# SAN FRANCISCO PLANNING DEPARTMENT

## Discretionary Review Full Analysis

*Date:* August 31, 2011  
*Case No.:* 2010.0479DD  
*Project Address:* 1456 Chestnut Street  
*Permit Application:* 2010.06.16.4608  
*Zoning:* RH-3 (Residential House, Three-Family)  
40-X Height and Bulk District  
*Block/Lot:* 0480/003E  
*Project Sponsor:* John Schlesinger, A.I.A.  
351 Valley Street  
San Francisco, CA 94131  
*Staff Contact:* Aaron Starr – (415) 558-6362  
[Aaron.Starr@sfgov.org](mailto:Aaron.Starr@sfgov.org)  
*Recommendation:* **Take DR and Approve the Project with Modifications**

A2.1

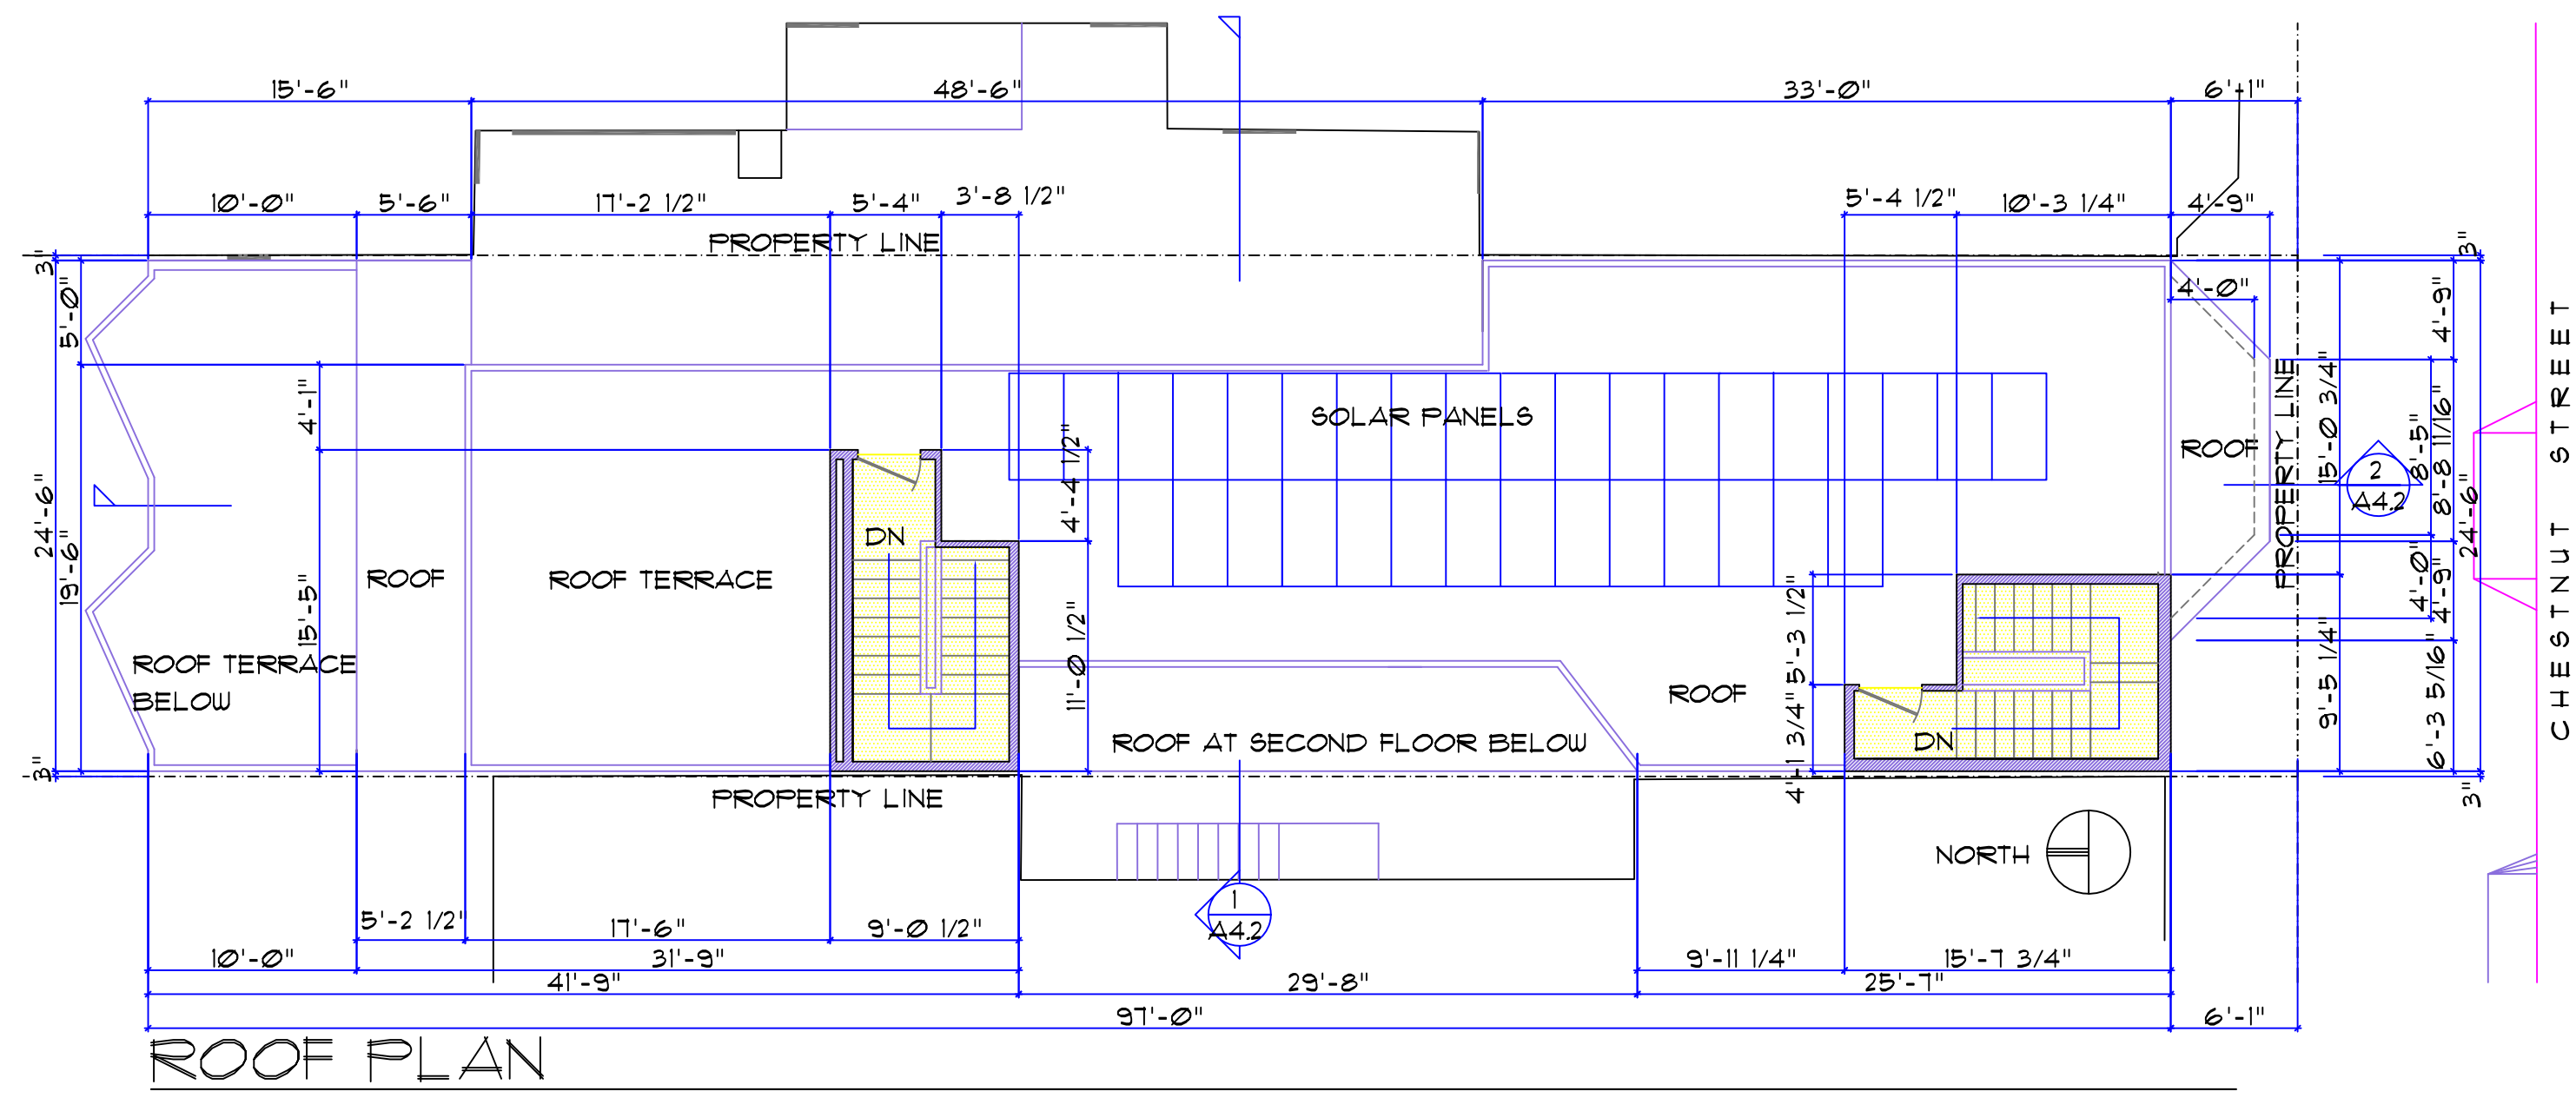
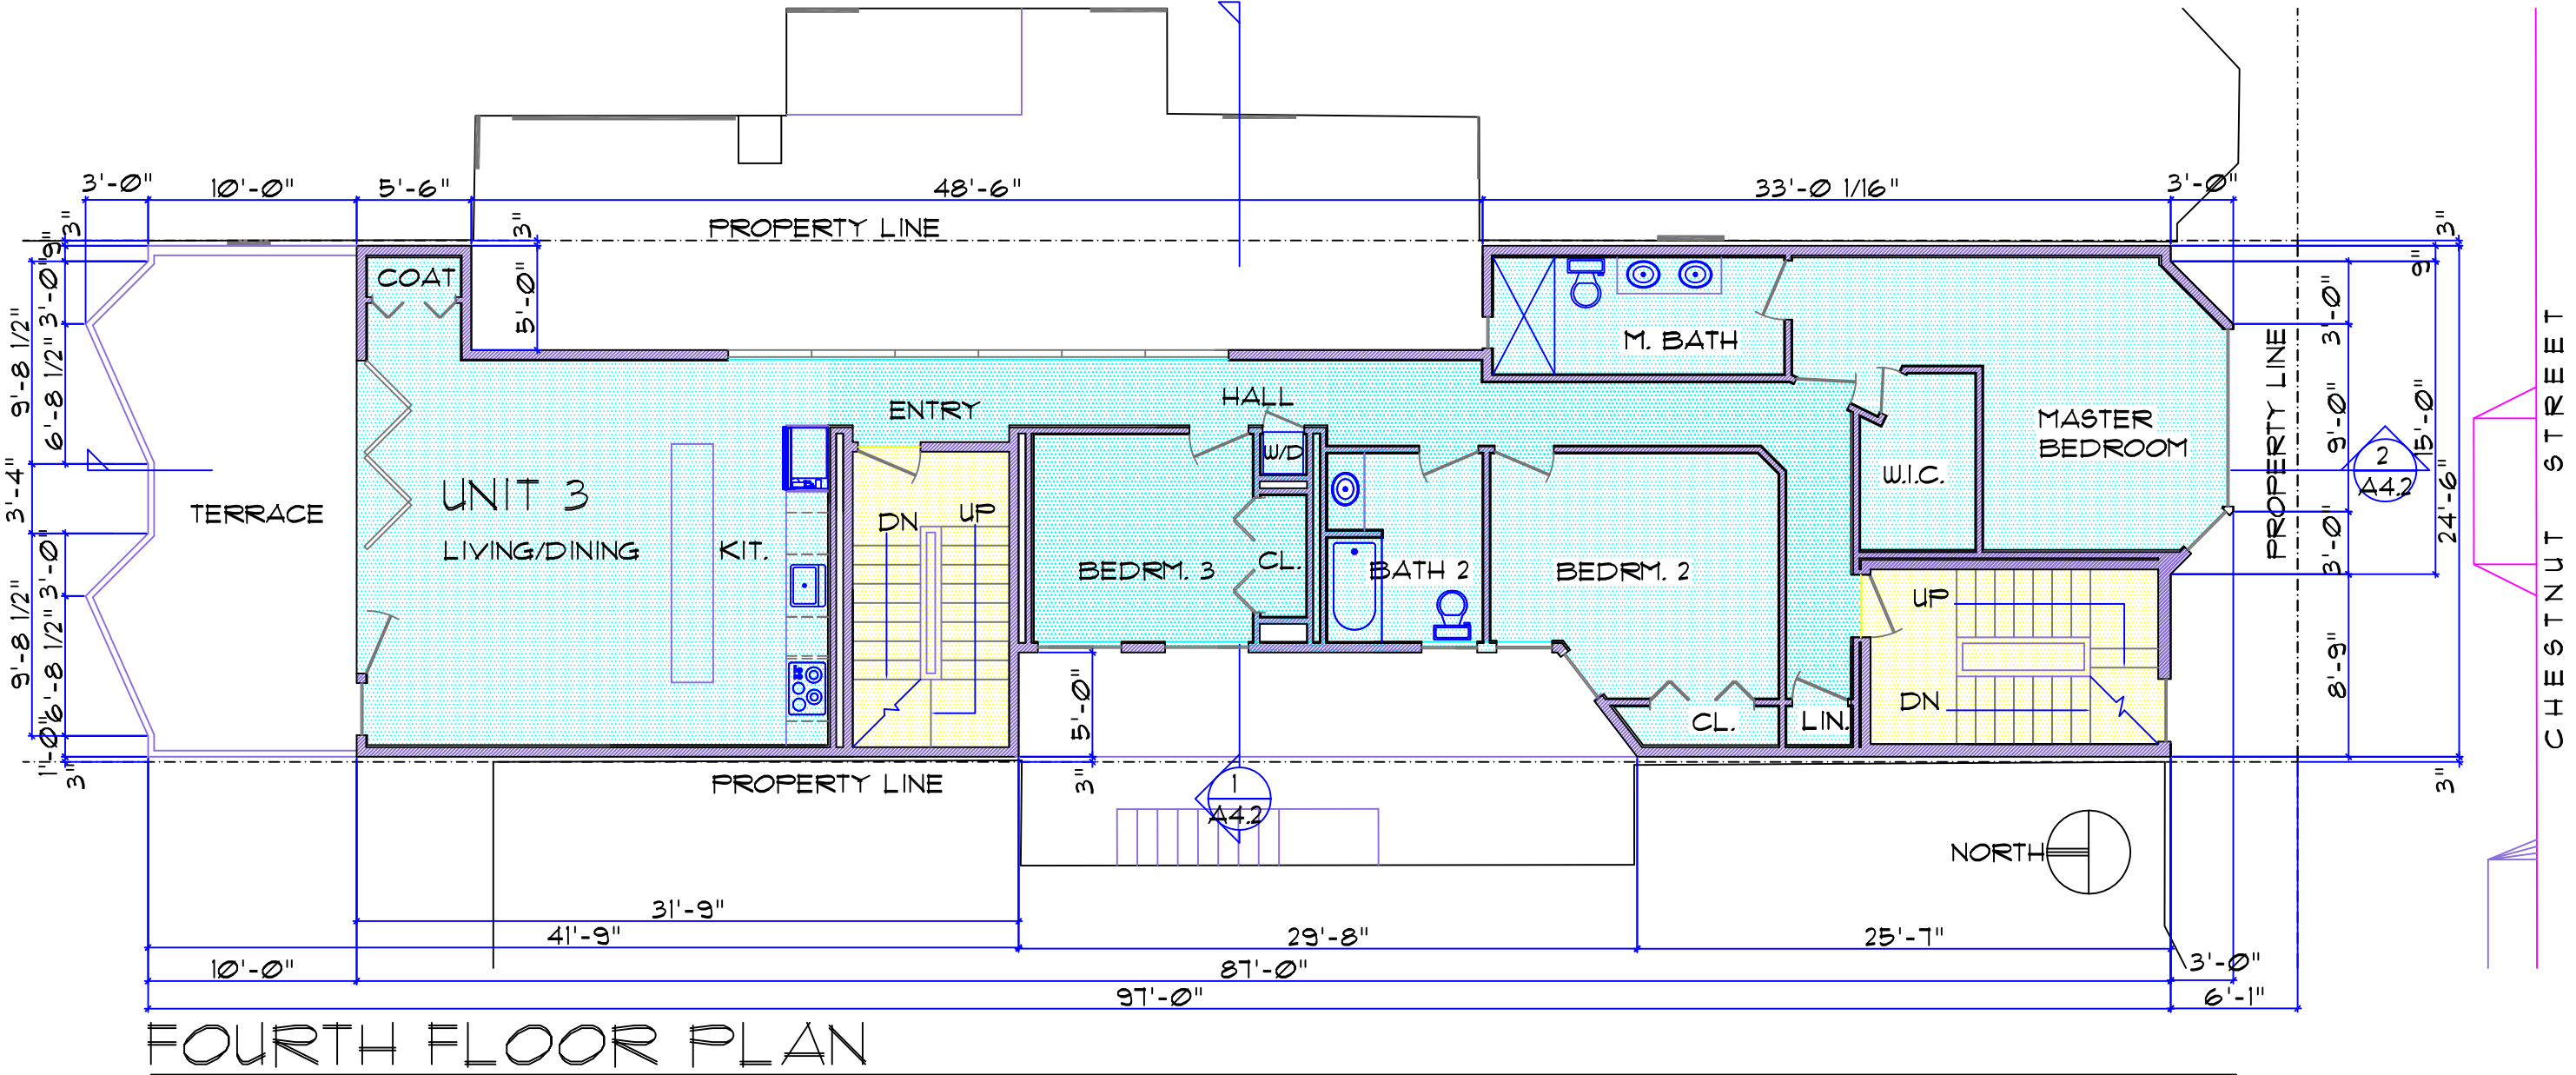
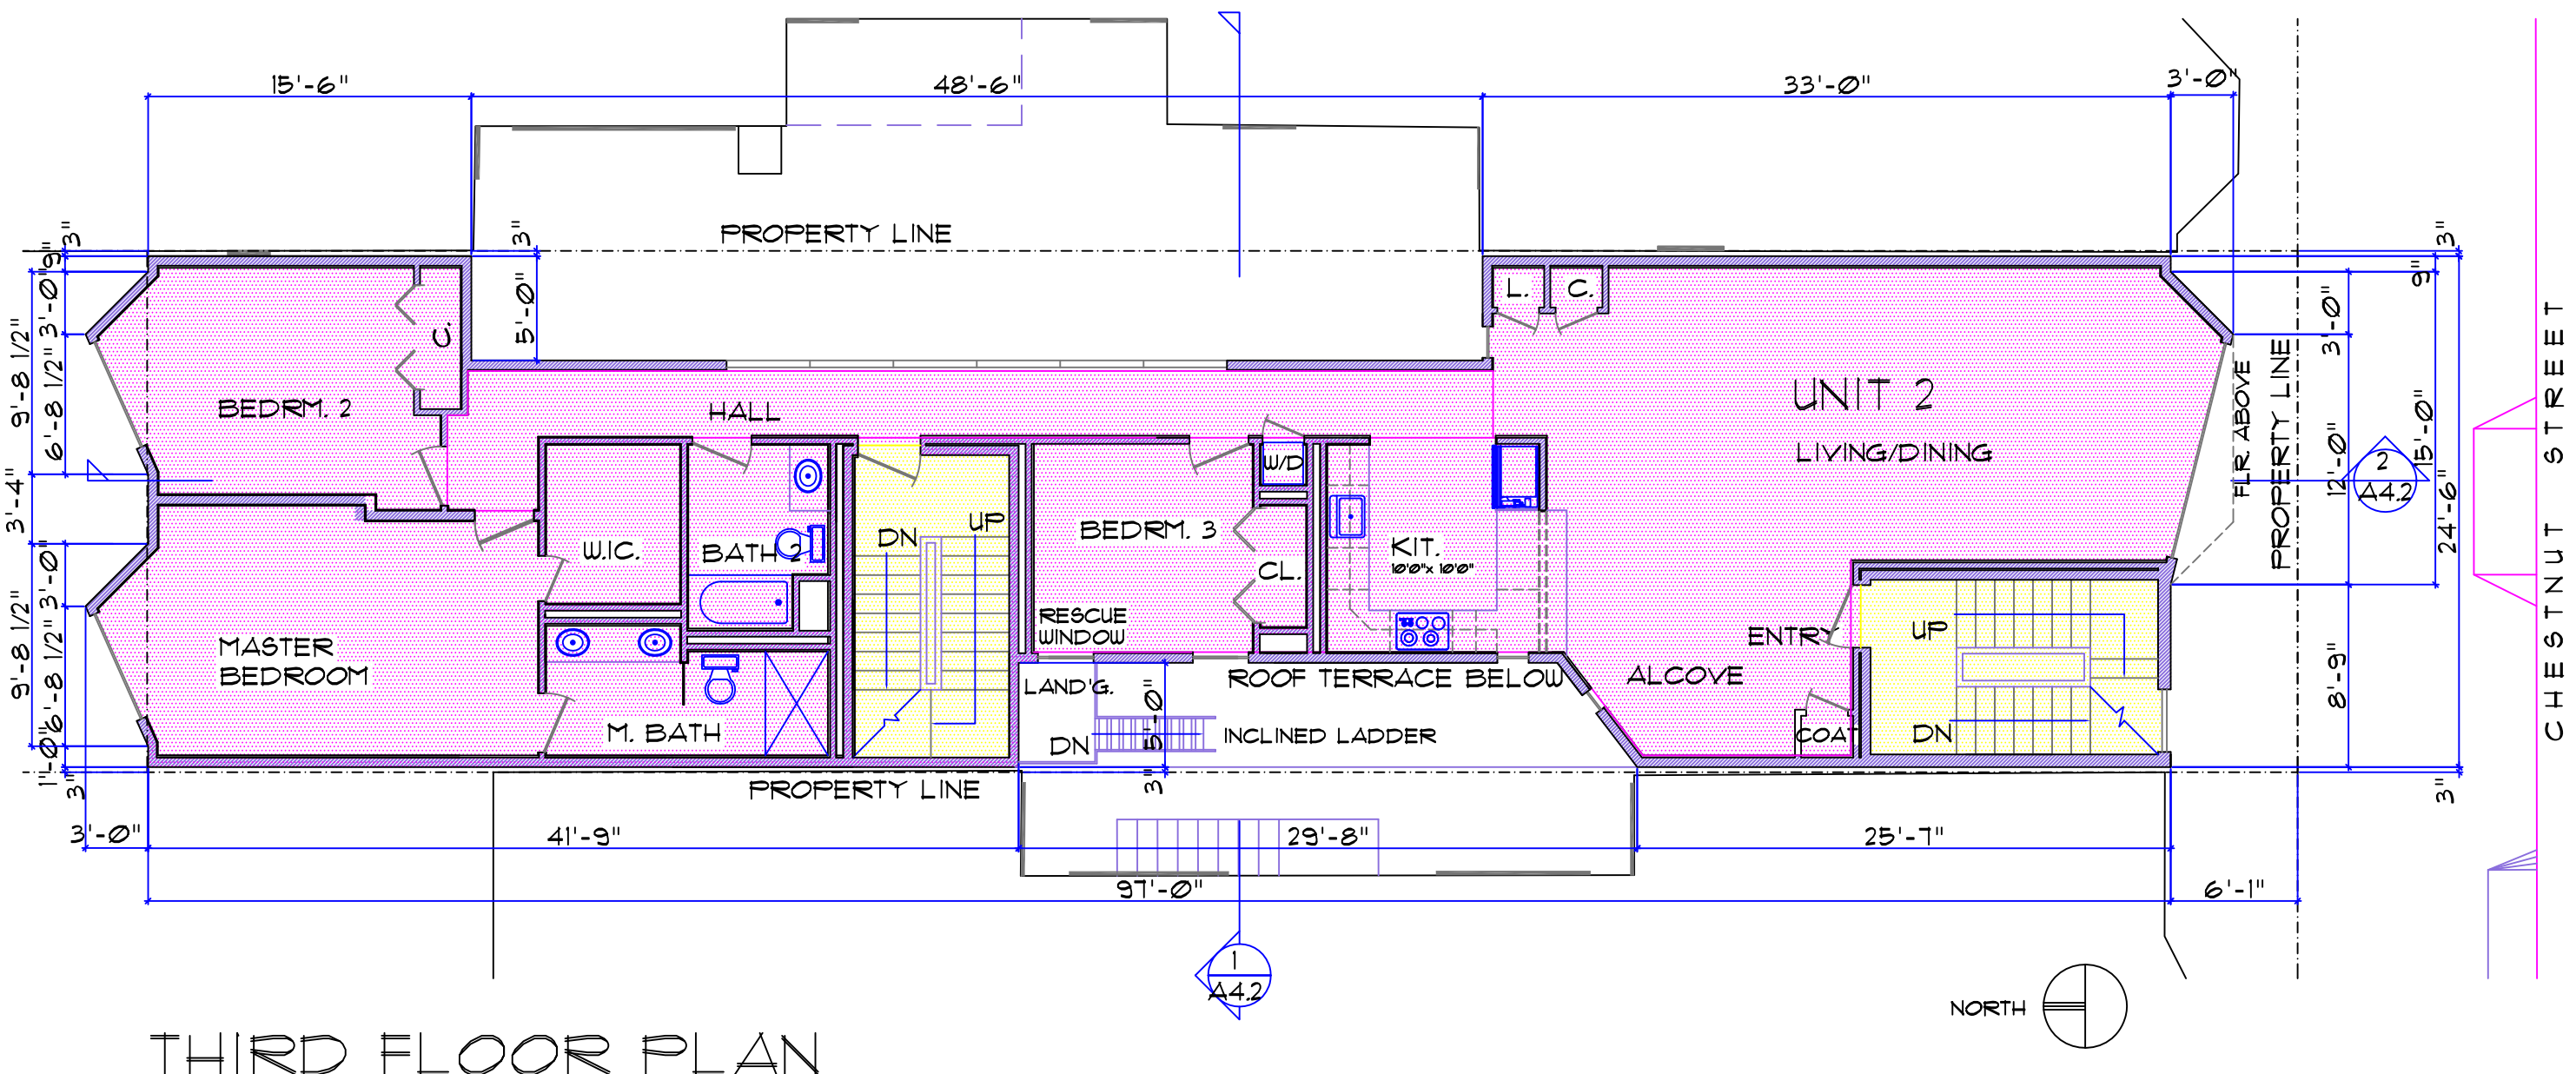
The RDT feels that the proposed depth of the project is appropriate, but has some concerns about the 4-story massing at the rear and its impacts on the smaller property to the west. As is typical, given these concerns the RDT asked that the project sponsor consider setting back the 4<sup>th</sup> floor in the rear to match the depth of the adjacent neighbor to the west. Also, the RDT suggested that there be a 10-foot side setback

against the shallower neighbor's property at the 2nd and 3rd floors. For the remaining 1-story portion at the west side property line, the Department asked that the deck railing be set back from the property line so that no fire wall would be required. These requirements were intended to minimize loss of light to the adjacent property to the west and to avoid a large solid blank wall at the property line.

**The Department is seeking the Commission's feedback on this specific issue.** RDT staff acknowledge the value of the larger-than-required lightwells, both to the proposed 3 units and the multiple units in the buildings on either side that have windows facing the lightwells. However, the large lightwells squeeze the floorplans of the proposed units into a barbell shape, which somewhat forces living areas and bedrooms to the front and rear of the site. The RDT's request for a 10-foot side setback on the west side therefore has a larger-than-usual impact on the floorplan, when combined with the proposed west side lightwell.

The Department also suggests that the stair penthouse be moved to the east side of the roof so that it would not be on the most visible side of the building as seen from the street. The proposal is a new building and is not limited by existing conditions.
